July 27, 2021  
KERN DELTA WATER DISTRICT  
SUNSET PONDS GRADING PROJECT

Attached is **Addendum #1** to the  
Sunset Ponds Grading Project

**KERN DELTA WATER DISTRICT – SUNSET PONDS GRADING PROJECT  
PRE-BID MEETING SUMMARY AND CLARIFICATIONS  
ADDENDUM #1 – JULY 27, 2021**

**J** SUNSET PONDS - LEVEE CROSS SECTION 1  
**12** POND 2 - NORTH EXTERIOR LEVEE - LOOKING EAST

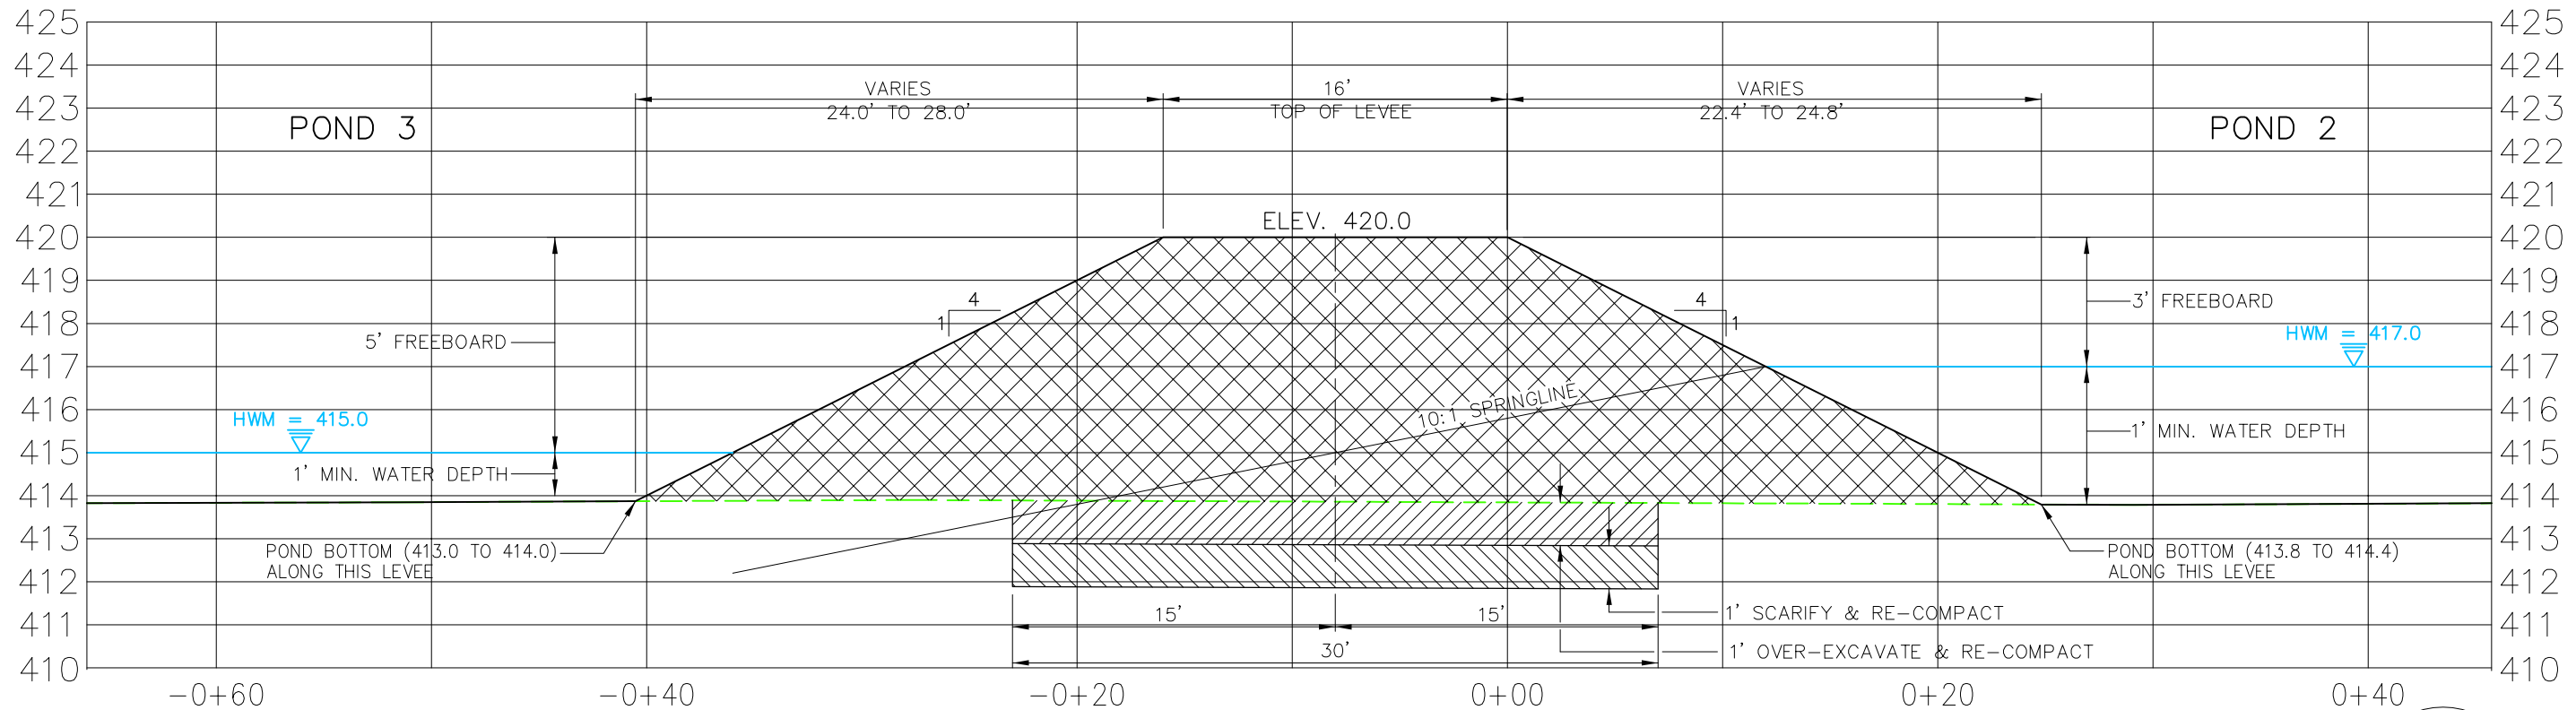
| 1                               | 07/27/21 | CORRECTION TO DETAIL J/12 |

**L** 13 SUNSET PONDS - LEVEE CROSS SECTION  
 POND 3 - EAST EXTERIOR LEVEE - LOOKING NORTH

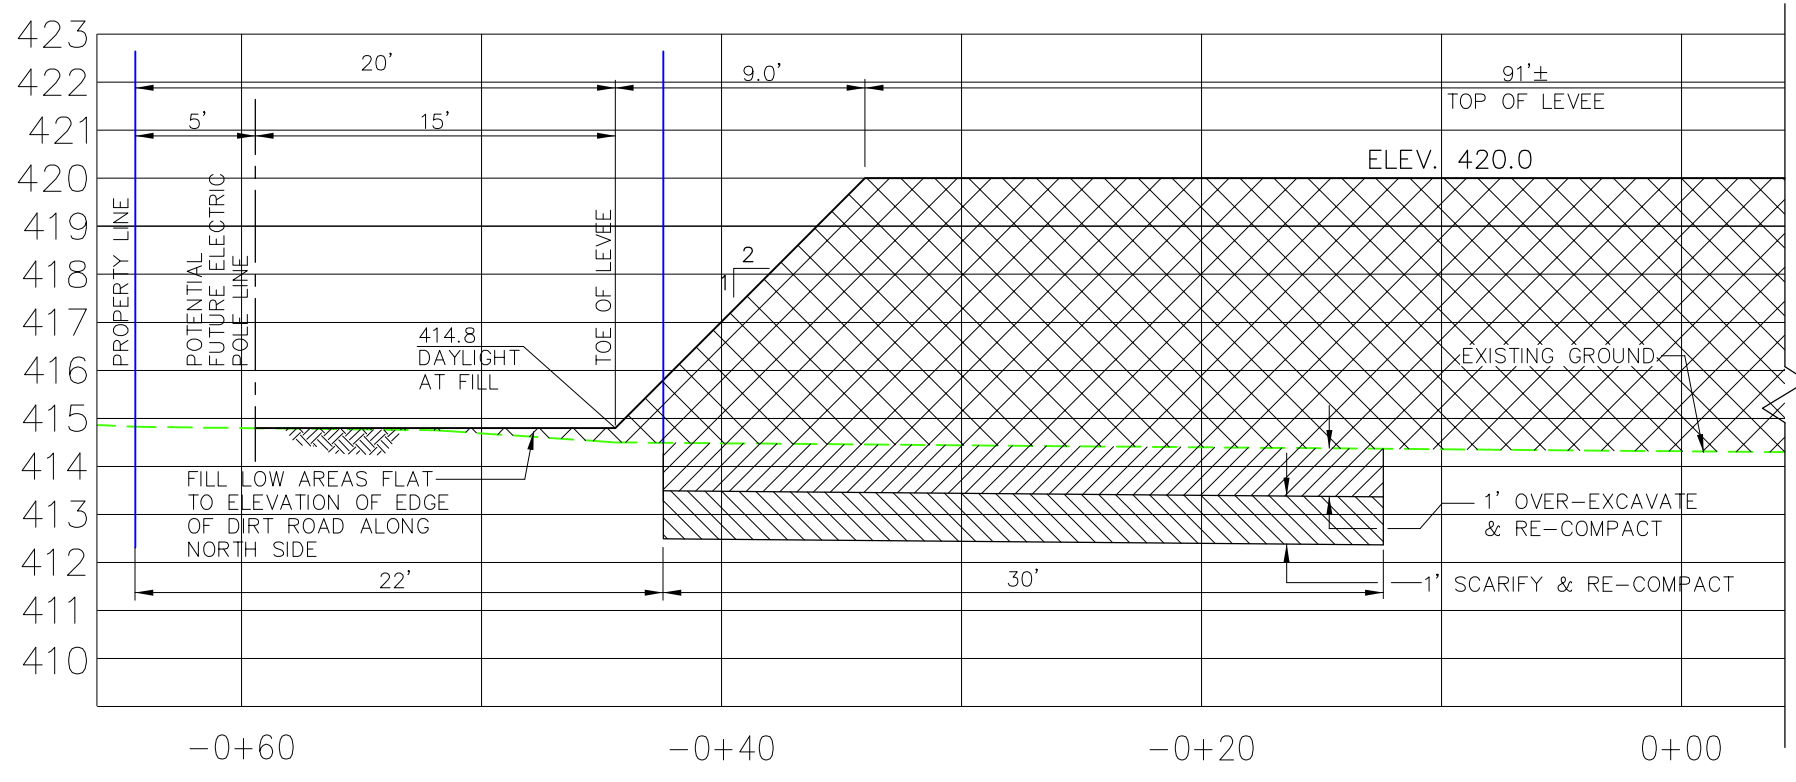
| REV. | DATE     | DESCRIPTION               |
|------|----------|---------------------------|
| 1    | 07/27/21 | CORRECTION TO DETAIL L/13 |

**PLAN**  
**A** GRAVITY DIVERSION STRUCTURE  
TWIN 42" RCP PIPES SCALE: 1" = 2'

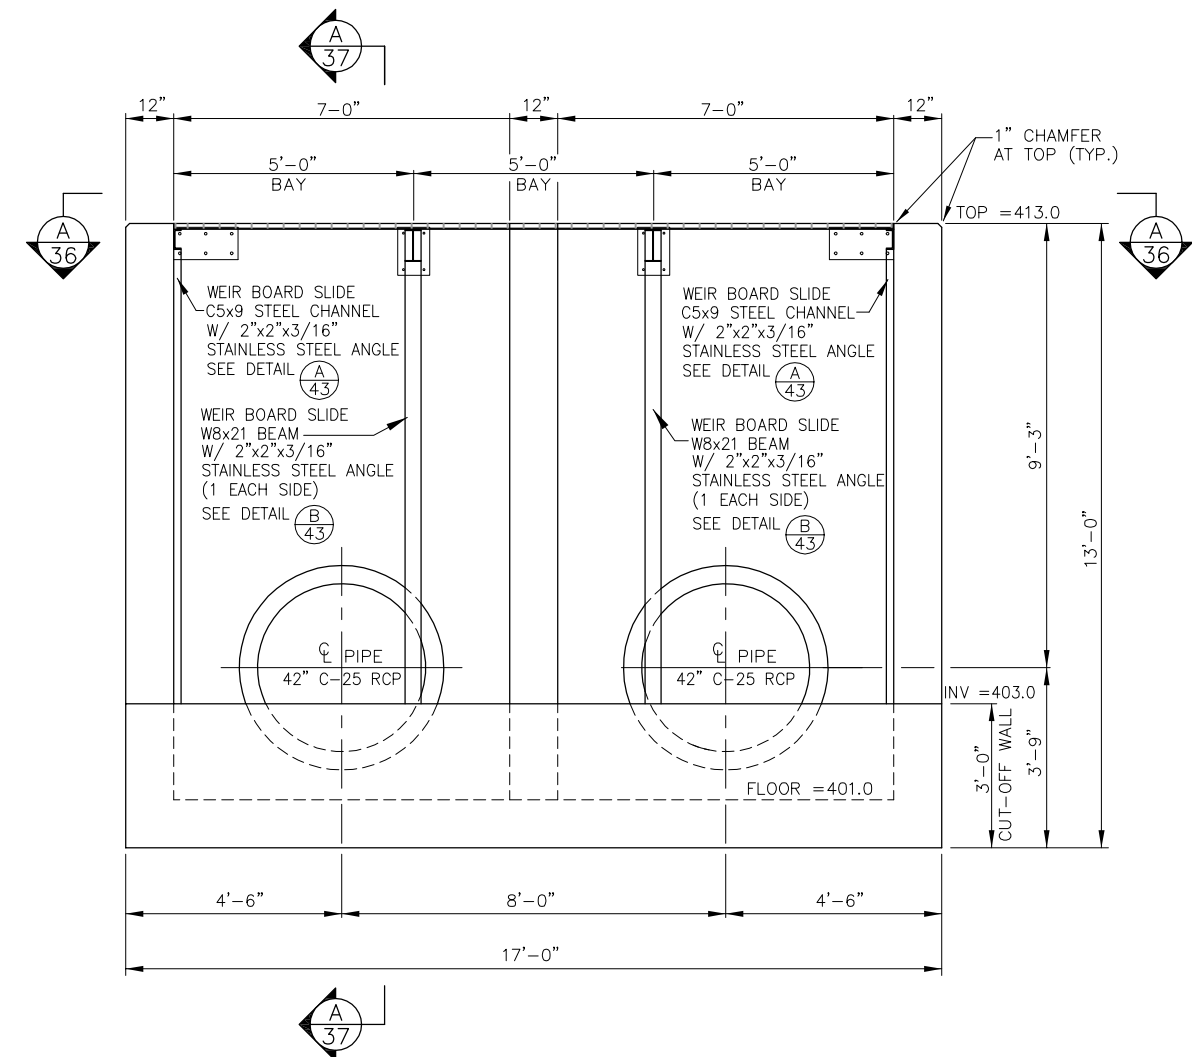
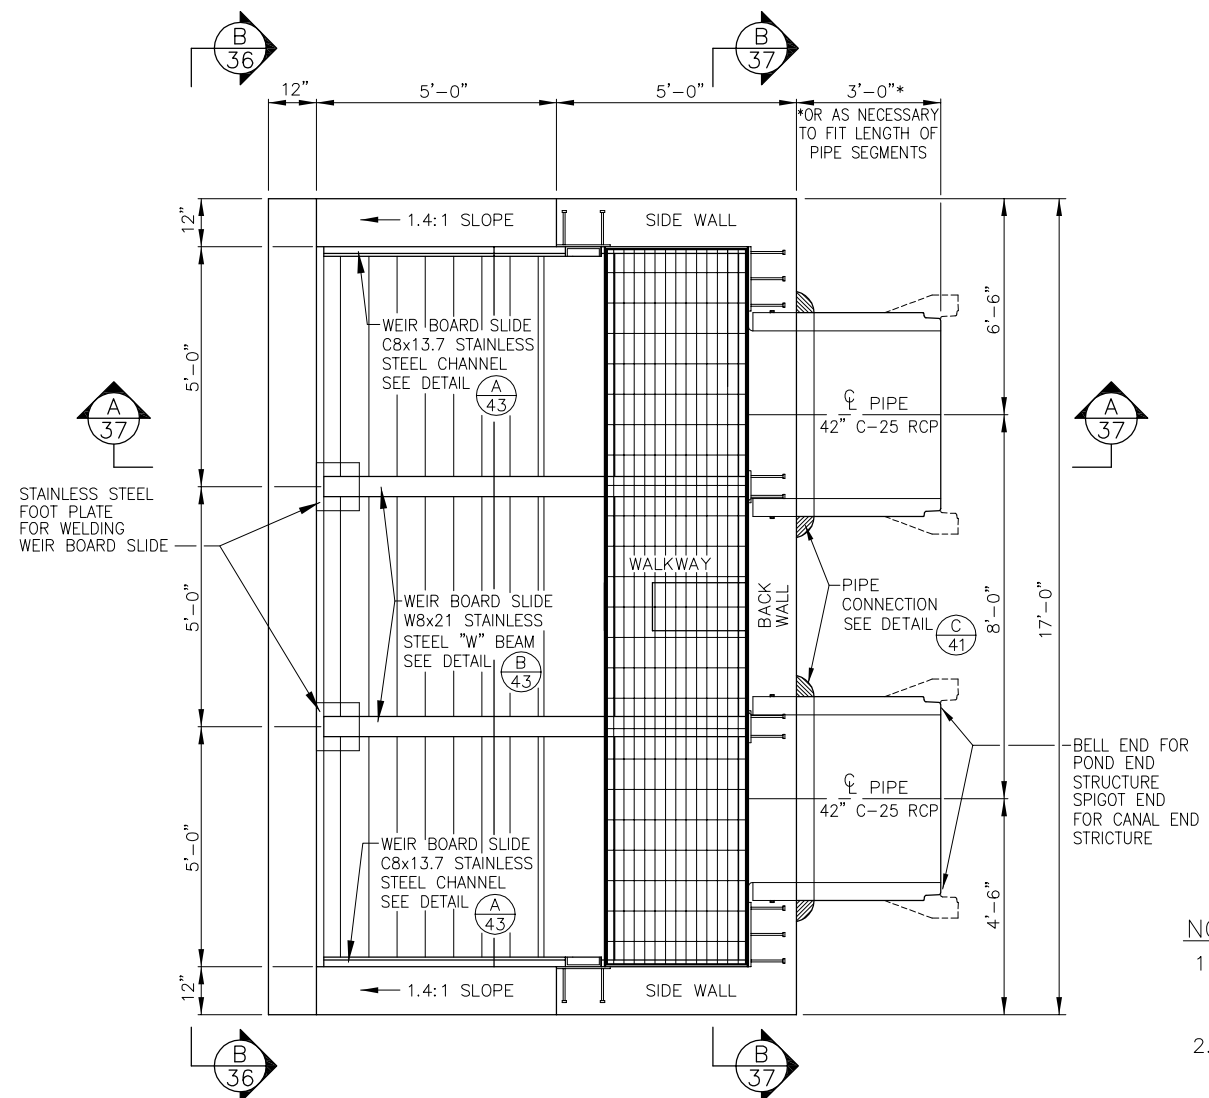
4. Section G – Concrete Structures and Piping: Changed Section G-3, b, 3 (page G-2), revising backfill operations to include pouring 1.5-sack concrete slurry up to 1’ above the top of the pipe instead of just up to the springline.
5. Construction Plan Sheets
  - a. Sheets 12 & 13 – Corrected error on cross sections J/12 and L/13: Text callouts for over-excavation and re-compaction and scarification and re-compaction were switched.
  - b. Sheet 36 – Corrected error on both details: Text changed from including C-50 RCP piping to C-25 RCP piping. The 42” RCP piping at the gravity diversion should be C-25, not C-50.

| 1                      | 07/27/21      | CORRECTION: 42" C-25 RCP, NOT C-50 |
